S E R V I C E N O T E

OmniBER 37718 / 37719 Comms Performance Analyzer

The following modification is recommended to eliminate potential overheating and premature failure of DS_n DS1 Drop (Demux) Port driver.

Figure 2. Position of Wire Link.

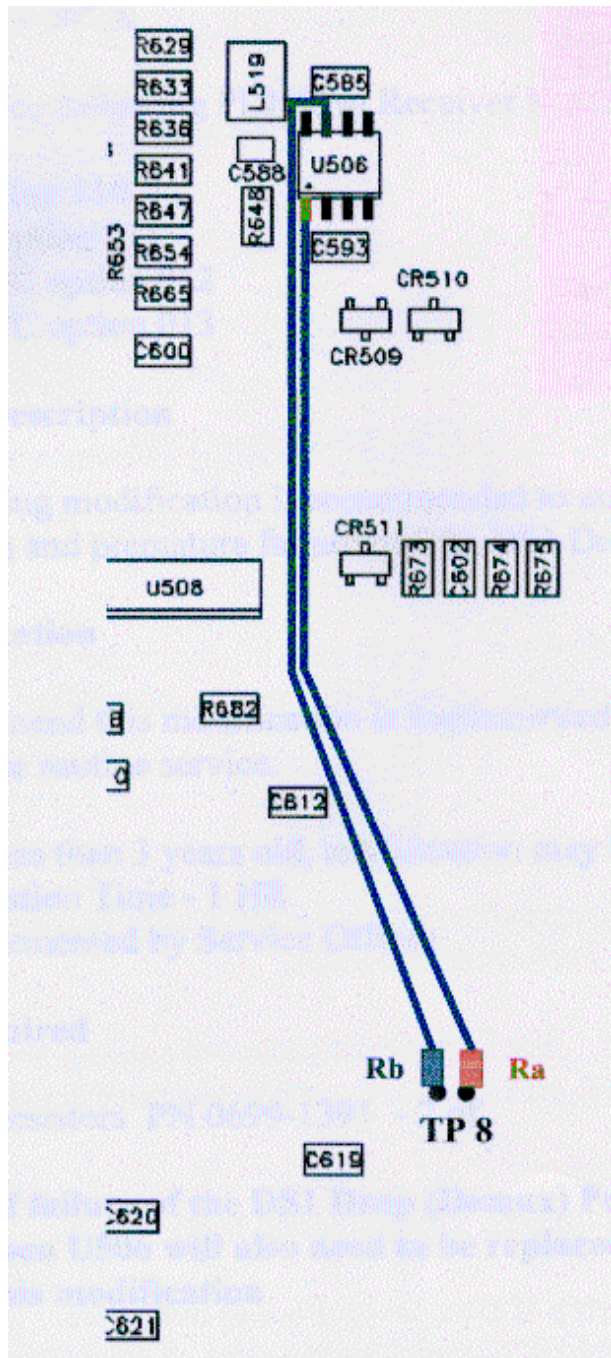
2. Note: Only perform this step if DS_n Drop Port is defective. Remove/replace U505 (PN 1820-8942) taking note of orientation.
3. Solder a 10k ohm resistor Ra (0699-1391) to rh pin of TP8.
4. Solder a 10k ohm resistor Rb (0699-1391) to rh pin of TP8.
5. Add a wire link from vacant end of Ra to U506 pin 1 using insulated wire (see Figures 1 and 2).
6. Add a wire link from vacant end of Rb to U506 pin 7 using insulated wire (see Figures 1 and 2).

7. Reinforce with epoxy.
8. Refit module and confirm correct operation of the Drop Port as in step 1.
9. Fit a label to the rear of the instrument to indicate that this Service Note has been implemented.
10. Record the modification on CSO for future records.
